OFFICIAL COORDINATION REQUEST FOR NON-ROUTINE OPERATIONS AND MAINTENANCE

COORDINATION TITLE- 18BON02 Nighttime Lamprey Operations at Bradford Island Fishway Entrances

COORDINATION DATE- 26 February 2018

PROJECT- Bonneville Dam

Figure BON-6. Diel Distribution of Adult Salmonids at Bonneville Dam Fishway Entrances and Exits (Keefer & Caudill 2008).
Figure 2. Borrowed from the 2018 draft Fish Passage Plan.

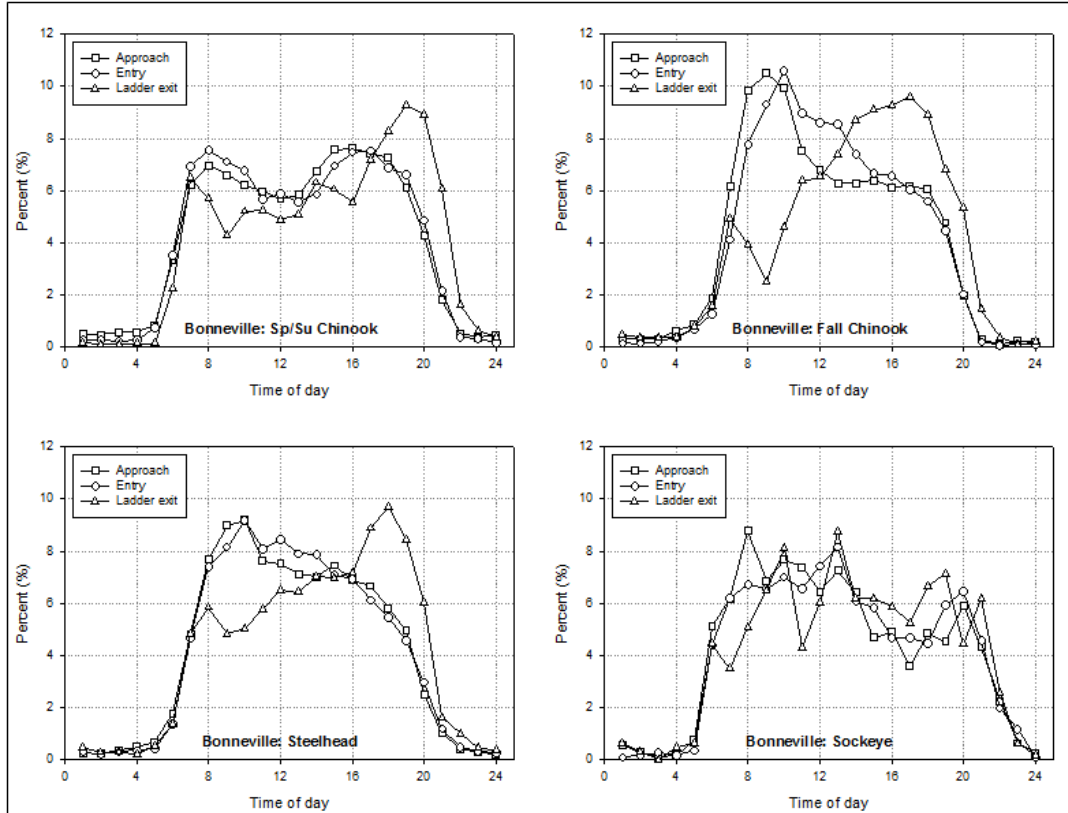
In June adult Sockeye and August through September adult Chinook Salmon are present in significant numbers. However, very few Sockeye and Chinook Salmon are approaching the Bonneville Dam fishway entrances between 2200 and 0400 and therefore impacts should be minimal as a result of the reduced nighttime flows (Figure 2).

10/13/16 FPOM: Swank supports removing the bottleneck at the entrance; then other bottlenecks can be addressed later. Conder reviewed diel sockeye passage and is comfortable with this operation since sockeye aren't passing from 2300-0400. Lorz thinks starting at 2200 would be fine. FPOM was generally supportive of this operation but wants more discussion with Tackley, Caudill at FFDRWG next week. PENDING discussion at FFDRWG 10/20/16.

Final coordination results – From the March FPOM meeting minutes: FPOM concurred with this action pending the time change to 2200-0400.
